PETITION FOR LEAVE TO AMEND

A M E N D M E N T

**AMENDMENT TO APPLICATION FOR
CONSTRUCTION PERMIT TO MODIFY FACILITIES**

**CARNEGIE-MELLON STUDENT GOVERNMENT CORP.
WRCT(FM), PITTSBURGH, PENNSYLVANIA**

FIGURE 2-A

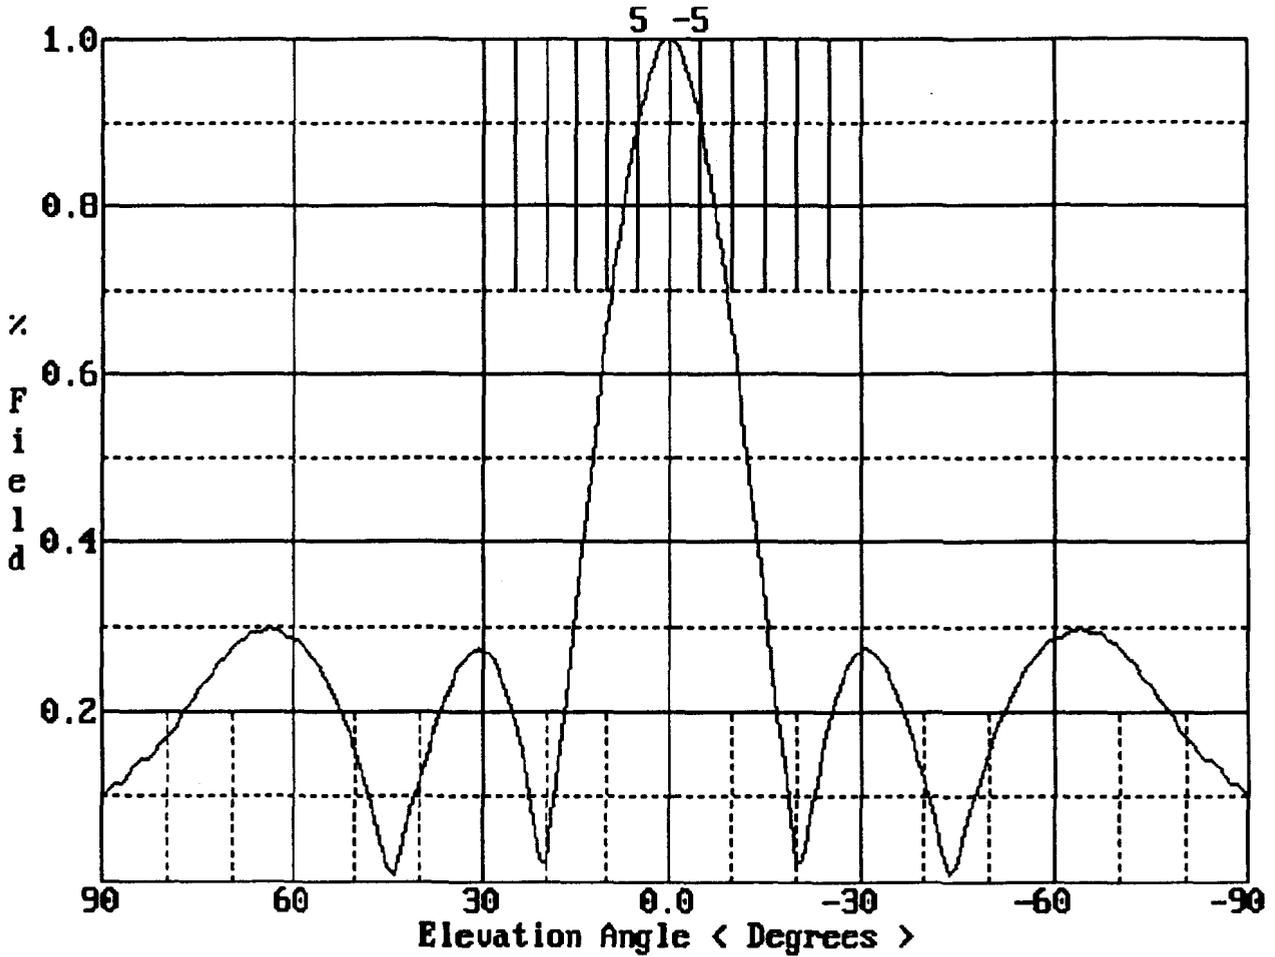
Both horizontal and vertical polarizations will be utilized. Horizontal and/or vertical parasitic elements will be installed, as appropriate, so that the composite (horizontal and vertical polarizations) pattern will be as close as possible to the pattern envelope shown in attached Figure 2-A.

Neither the horizontal nor the vertical radiation component of the pattern in Figure 2-A changes more than 2 dB per 10 degrees of azimuth, nor does either component exceed a maximum-to-minimum radiation ratio of 15 dB.
